# COMPLETE MONOGRAPH

## **2022 GROUP B PROPOSED CHANGES TO THE I-CODES ROCHESTER COMMITTEE ACTION HEARINGS**

2021-2022 Code Development Cycle, Group B (2022) Proposed Changes to the 2021 *International Codes*

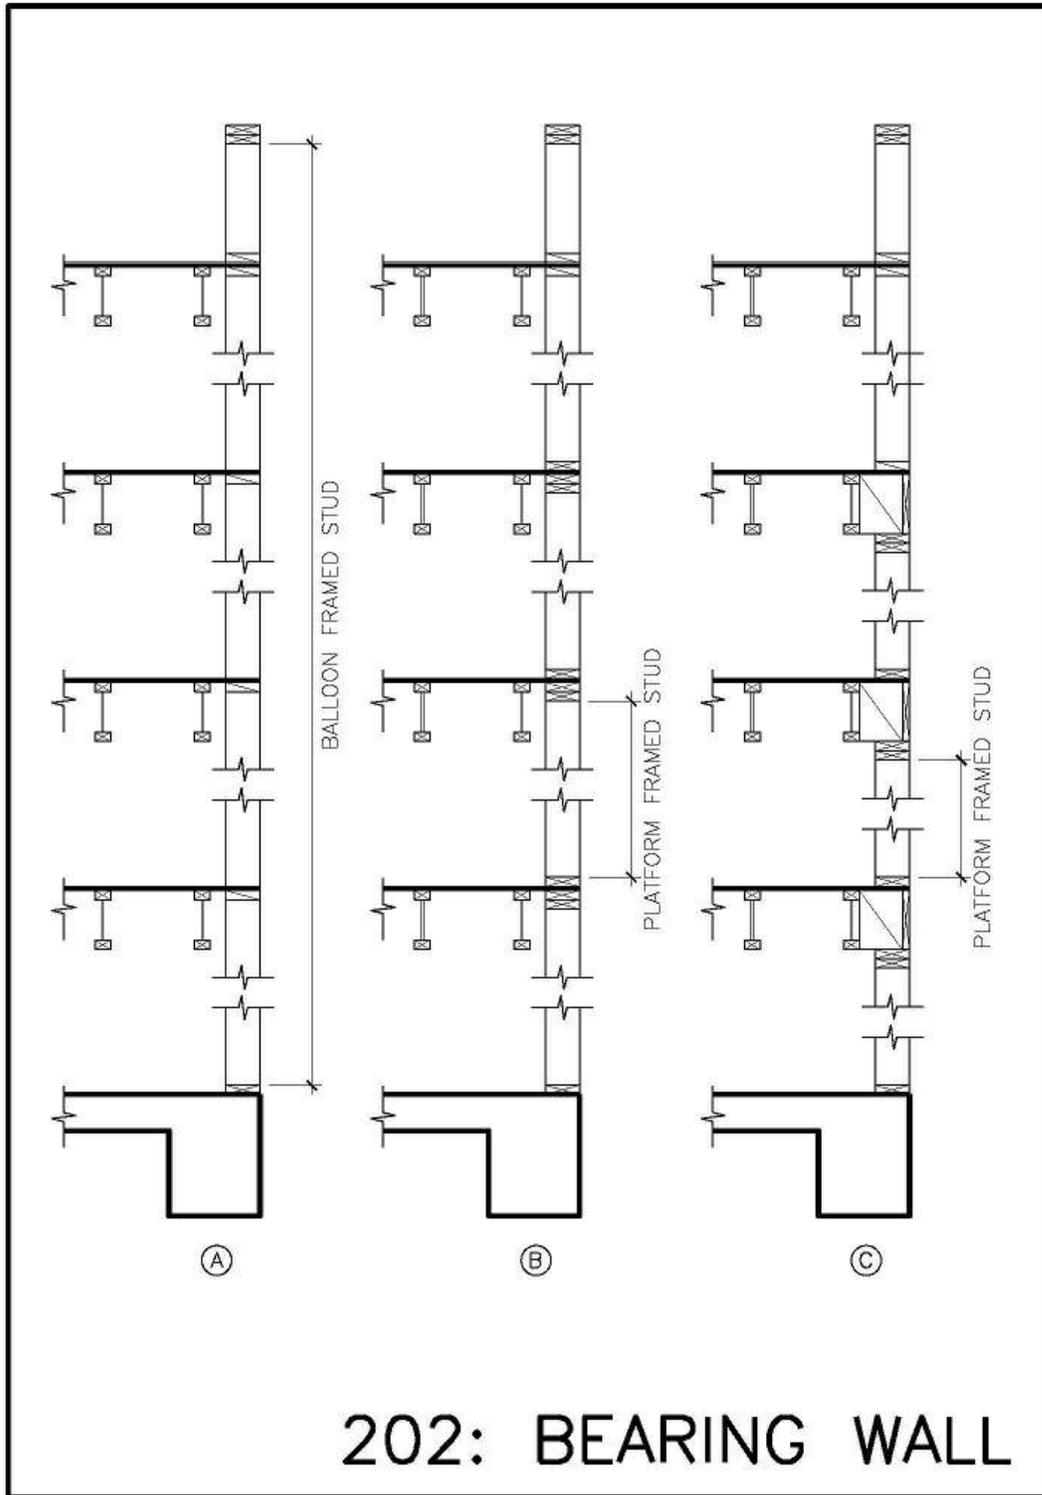
When light frame walls are platform framed as in Details B or C there is disagreement between some. The same height of wall from foundation to top of parapet with the same 100 pound per linear foot or less imposed load from the roof and wall sheathing is now considered by some to be load bearing because the segment of platform framed wall above is considered to impose additional load on the segment of platform framed wall below. Since the wall segments are framed separately some choose to ignore the part of the definition that says to neglect the weight of the wall.

The key issue from an intent standpoint in the code is exterior and interior bearing walls that could result in a collapse of the structure if compromised by fire deserve greater protection depending on the height and number of stories of the building. Those who feel the platform framed walls in Details B or C are bearing walls state the wall segments above could fall if the segment below carrying their weight is compromised by fire or hit by a car.

**FIGURE 1609.3(11) BASIC DESIGN WIND SPEEDS, V, FOR RISK CATEGORY I BUILDINGS AND OTHER STRUCTURES IN HAWAII**

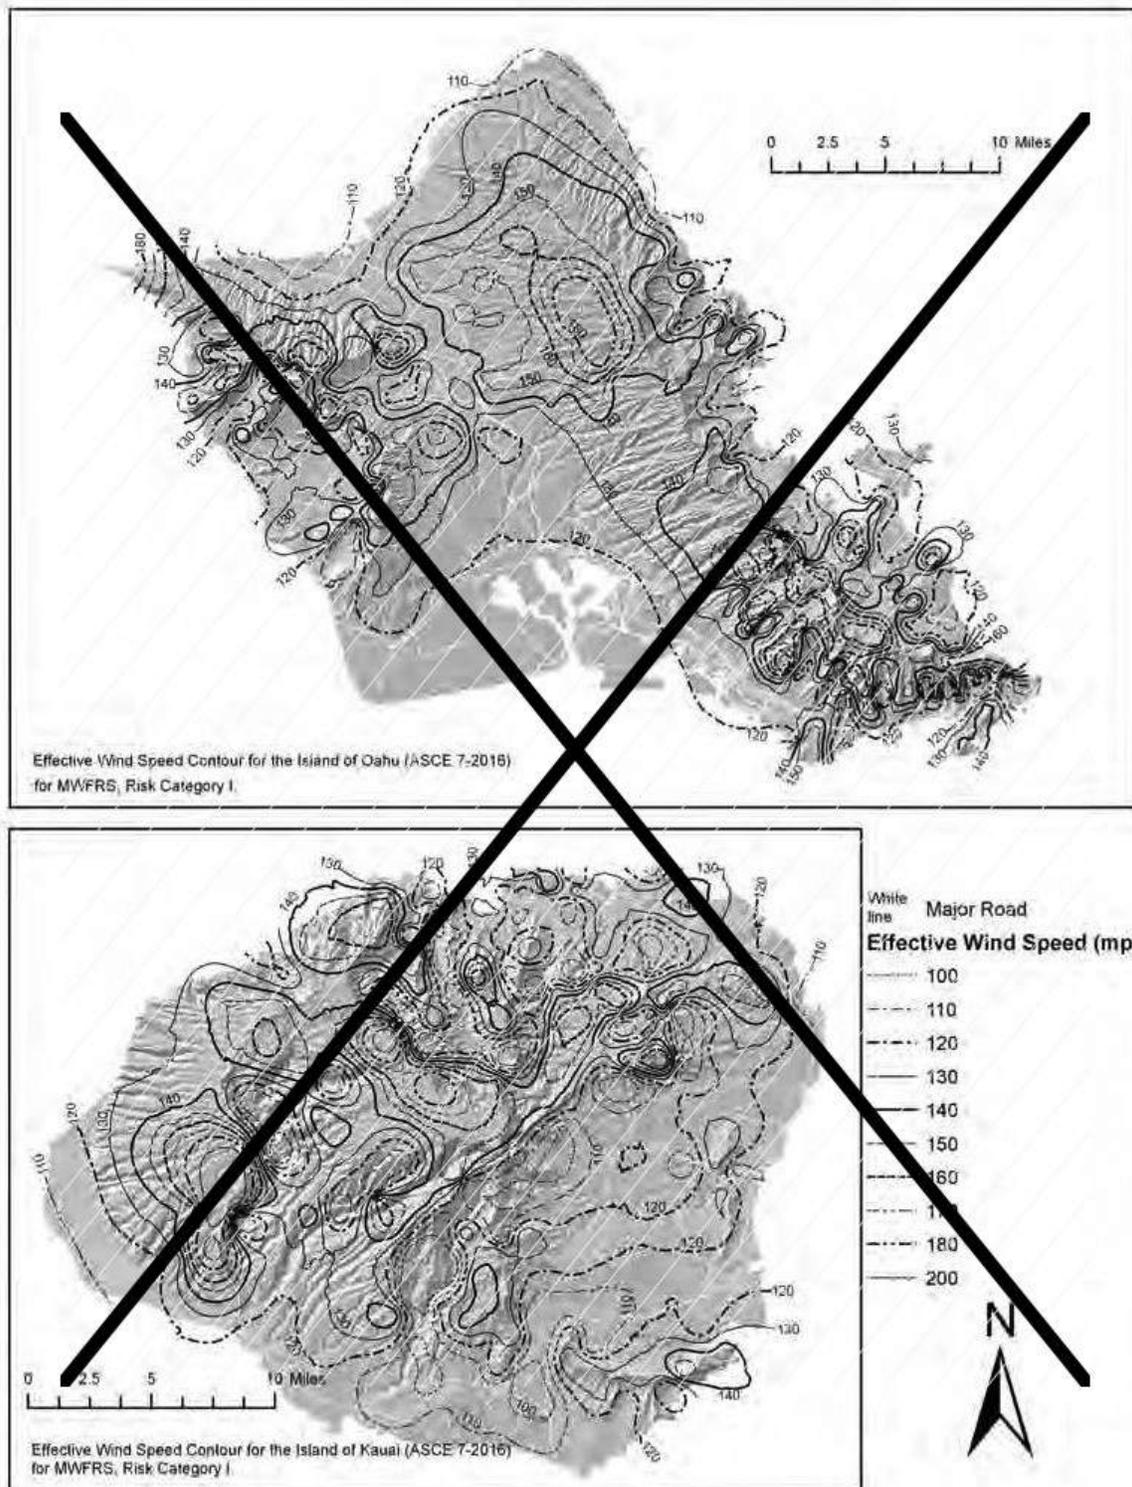
For *Risk Category II* buildings and structures and *Risk Category III* buildings and structures, except health care facilities, the windborne debris region shall be based on Figure ~~1609.3(1)~~ 1609.3(2). For *Risk Category III* health care facilities, and *Risk Category IV* buildings and structures and *Risk Category III* health care facilities, the windborne debris region shall be based on Figure ~~1609.3(2)~~ 1609.3(3) and Figure 1609.3(4), respectively .

**FIGURE 1611.1(1) 100-YEAR, 1-HOUR RAINFALL (INCHES) WESTERN UNITED STATES**

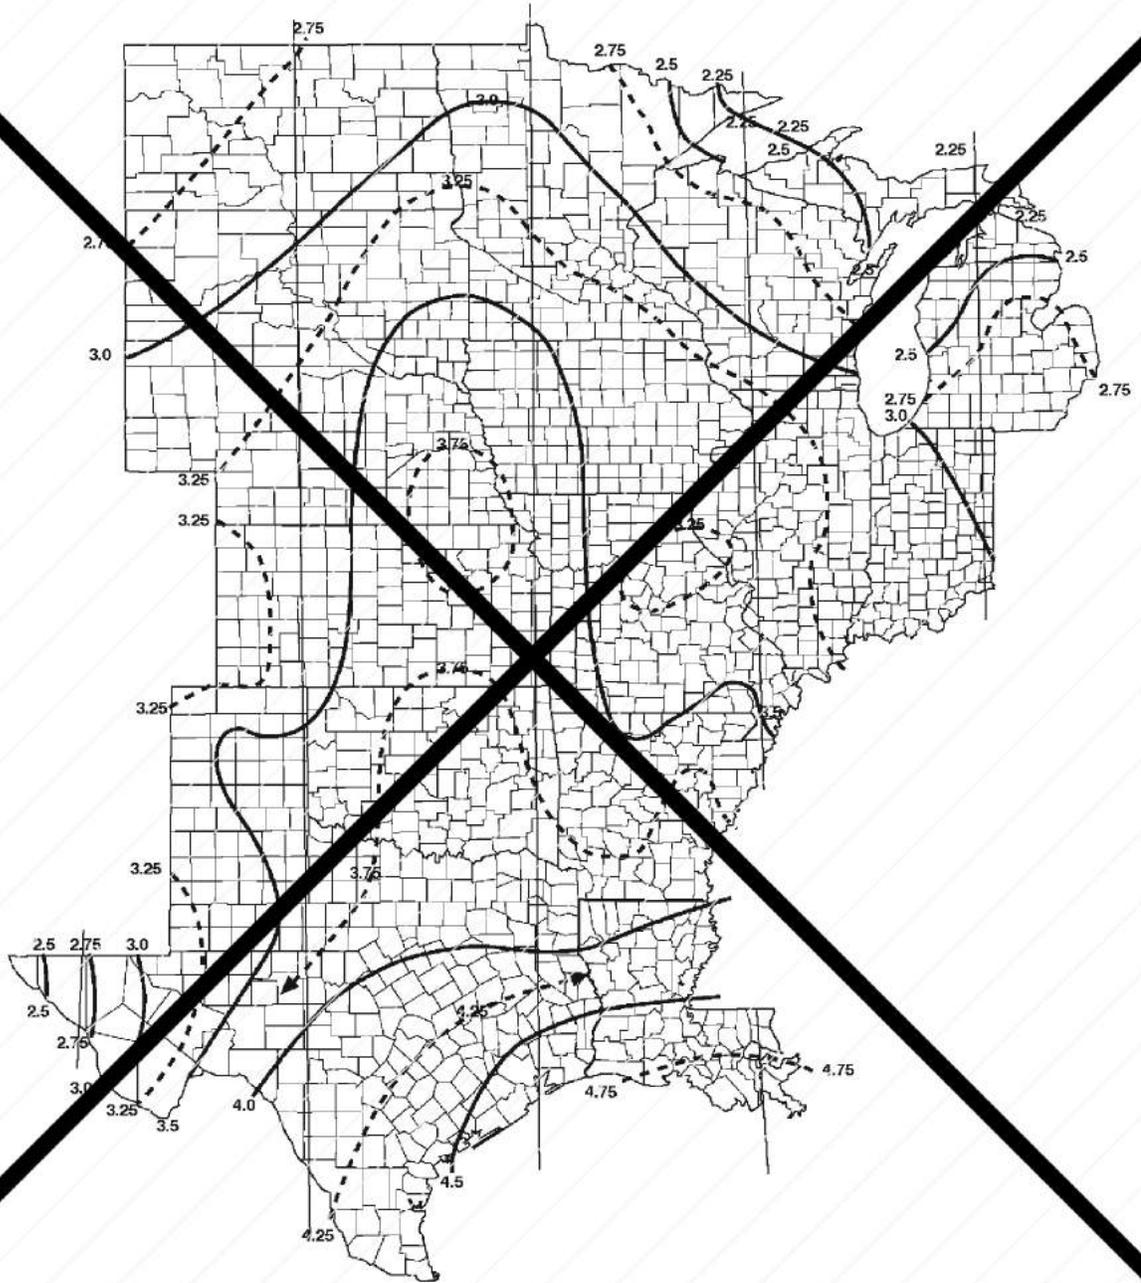
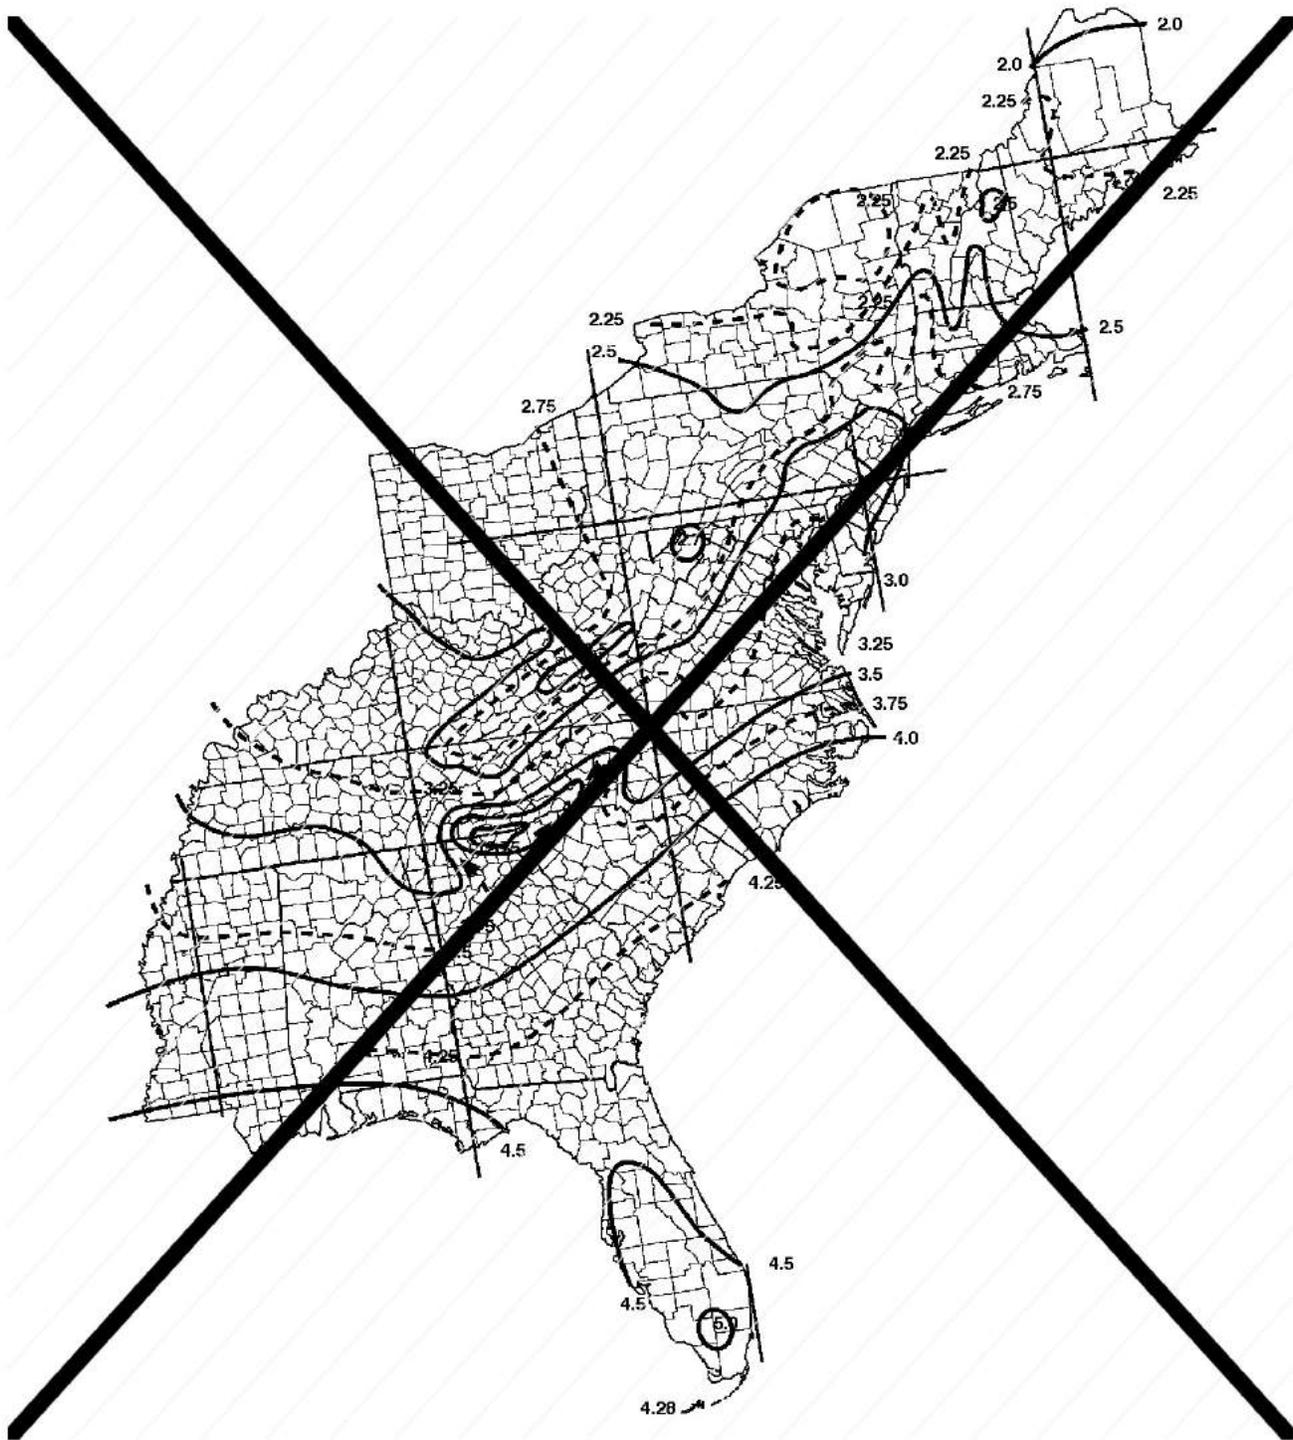
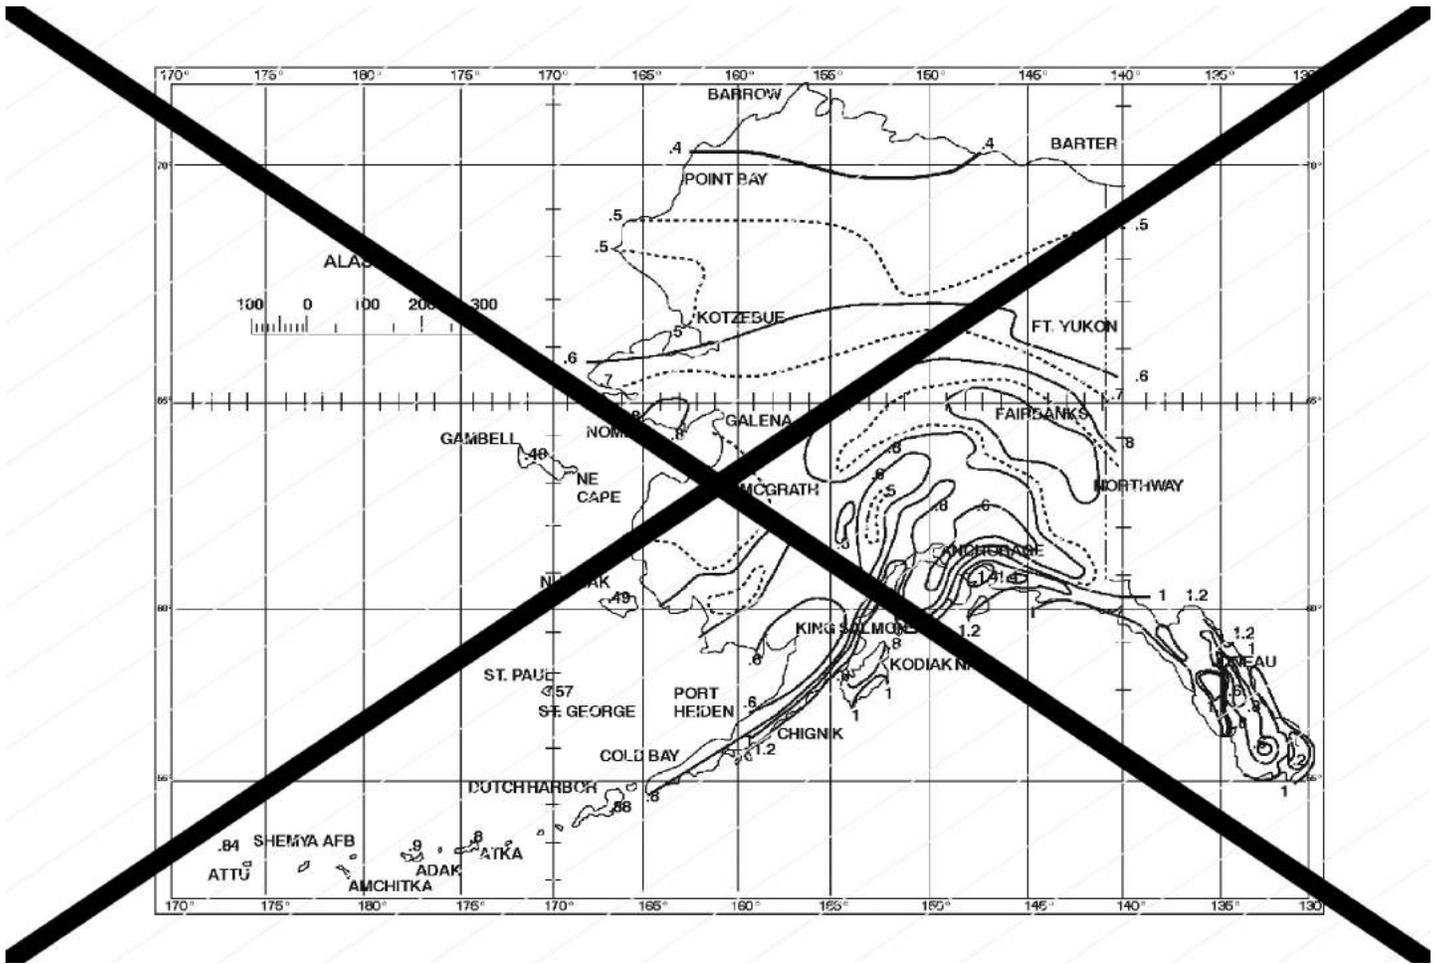
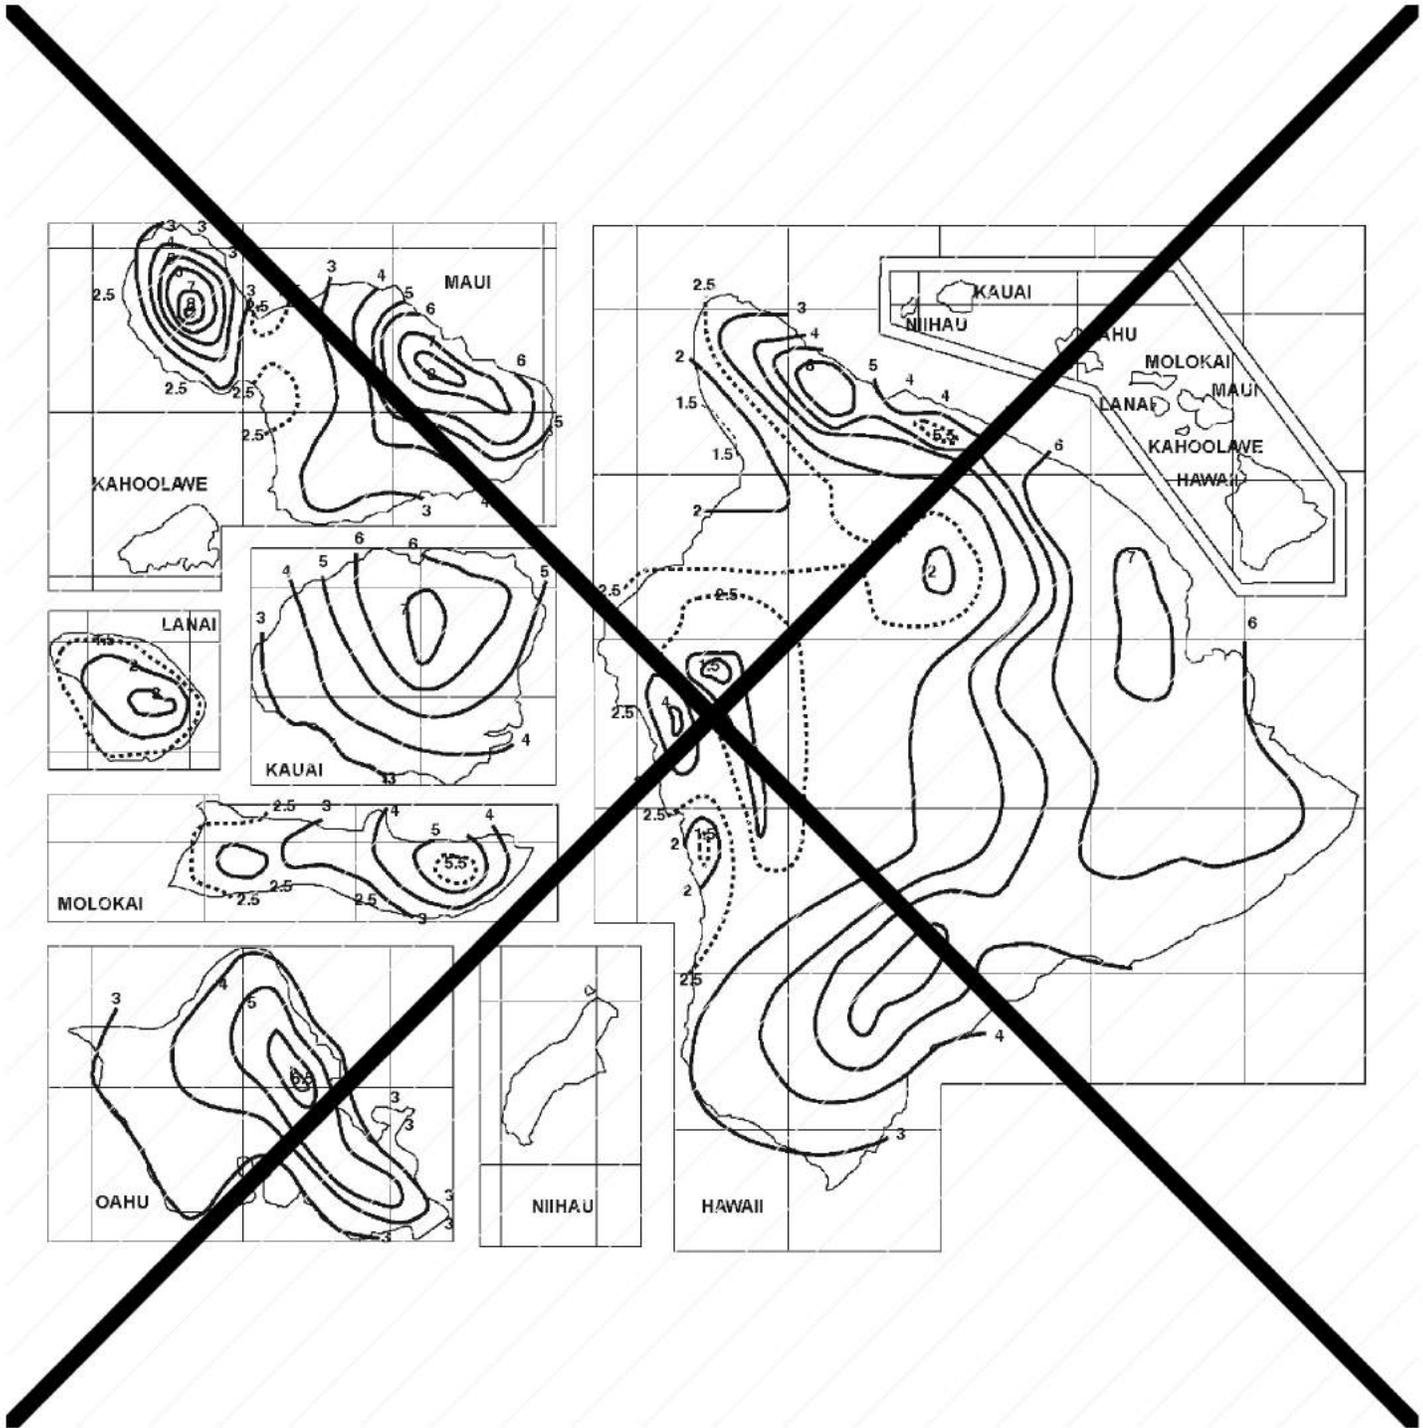
Delete without substitution:
